802.3dj D1.3 Comment Resolution Common Track

Matt Brown (Alphawave Semi), 802.3dj Chief Editor
Leon Bruckman, Nvidia
Jeff Slavick, Broadcom
Adee Ran, Cisco

- This slide package was assembled by the 802.3dj editorial team to provide background and detailed resolutions to aid in comment resolution.
- Specifically, these slides are for the various common track comments.

Figure 174A-4—Test configuration for a PHY using PCS counters

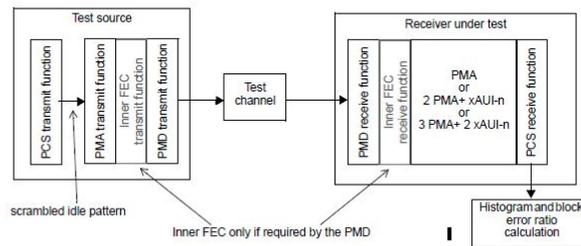
It is not clear what is "stress" or where it is applied in the lane.

In point a) change: "with no stress applied to any lane" to "with no stress applied to the receiver of any lane"
 In Point b) change: "with stress applied only to lane i" to: "with stress applied only to the receiver of lane i"

PROPOSED ACCEPT IN PRINCIPLE.

Pending review of slides with topic "Block error ratio stress" in the following editorial contribution:

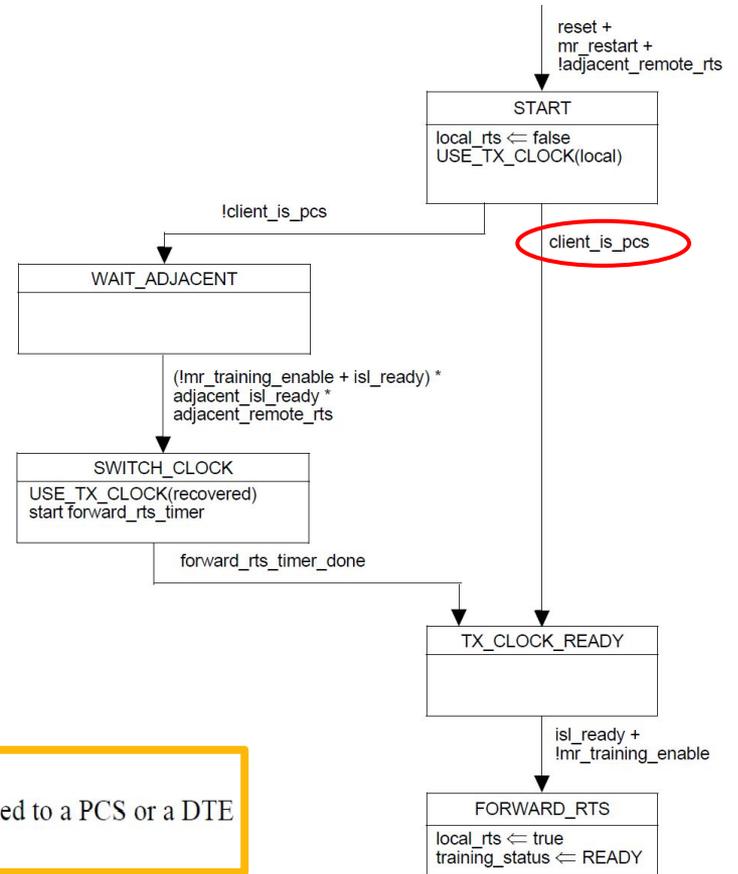
"other" interface is a bit ambiguous and the listed situations are the typical use case but does not cover all use cases. As a remote PCS (after a XS) could do either local or clock forwarding modes.

Rename client_is_pcs to be "uses_local_clock_only" and update the definition to be "Boolean variable that indicates if the PMA will never swap to a forwarded clock. For example this will be true for the first PMA below the RS."

Replace both uses of client_is_pcs with uses_local_clock_only in Fig 178B-7

- The name of the variable should be a description of the effect, rather than an (incorrect) assumption of when it is set.
- Rename **client_is_pcs** to **uses_recovered_clock**
- Makes adjustments in the state diagram (logic inversion)

- ACCEPT IN PRINCIPLE
- Rename “client_is_pcs” to “uses_recovered_clock” (logic inverse) and update the definition to be “Boolean variable set to true to indicate that the AUI component or PMD uses a clock recovered from another interface to drive its output when tx_mode = data. Otherwise it is set to false.”
- In Figure 178B-7 change:
 - “client_is_pcs” to “!uses_recovered_clock”
 - and “!client_is_pcs” to “uses_recovered_clock”
- Add MDIO variable to configure uses_recovered_clock

XGMII extender

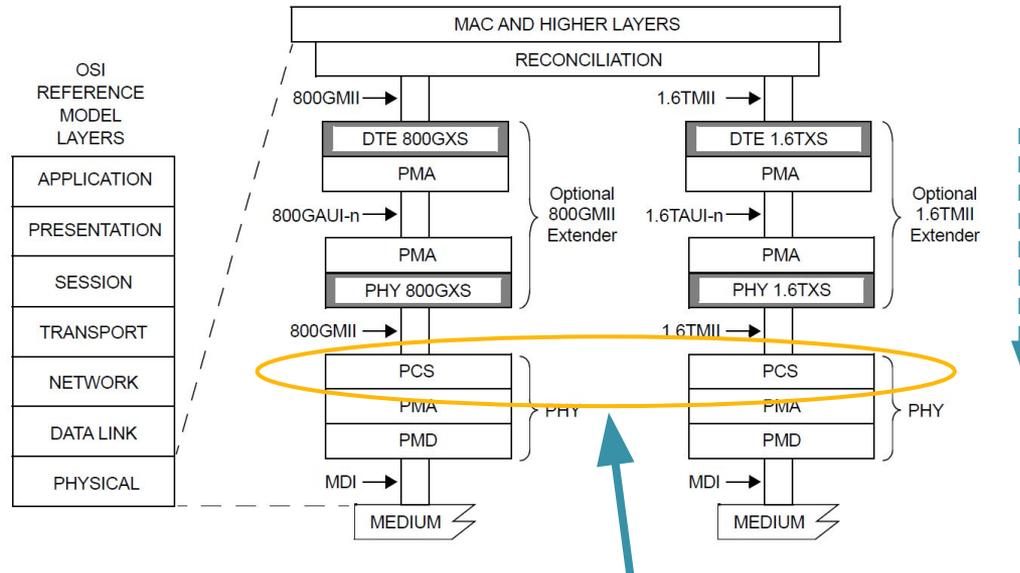
In mission mode
PCS may forward the received clock
- or -
use local clock + rate adaptation (idles)

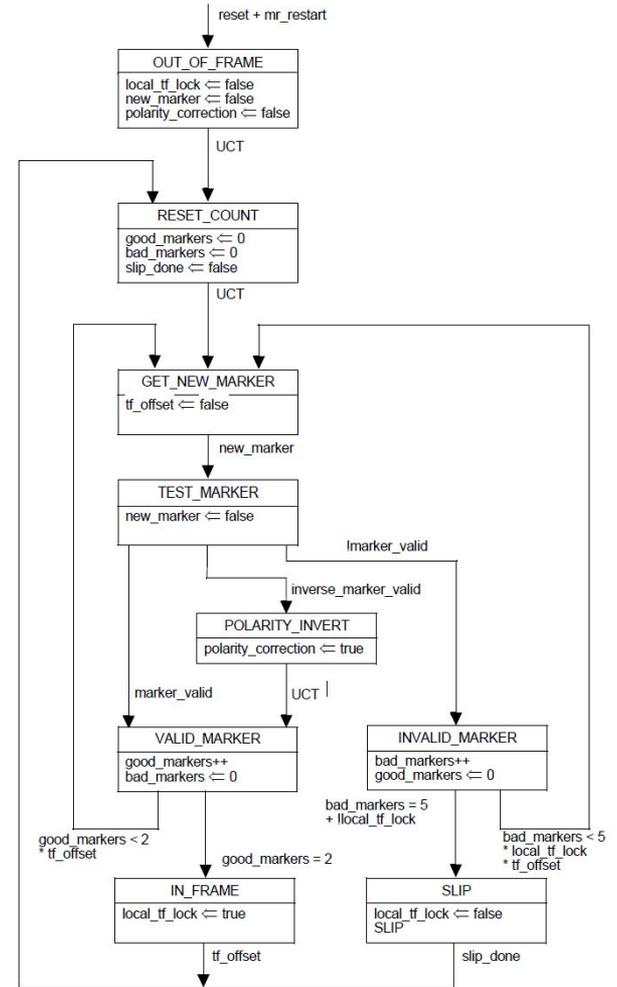
Fig 178B-9 needs to clarify the transitions out of TEST_MARKER.

Change the transition from TEST_MARKER to INVALID_MARKER to be "(!valid_marker * inverse_valid_marker) + (polarity_correction * inverse_valid_marker)"

Change the transition from TEST_MARKER to POLARITY_INVERT to be "!polarity_correction * inverse_marker_valid"
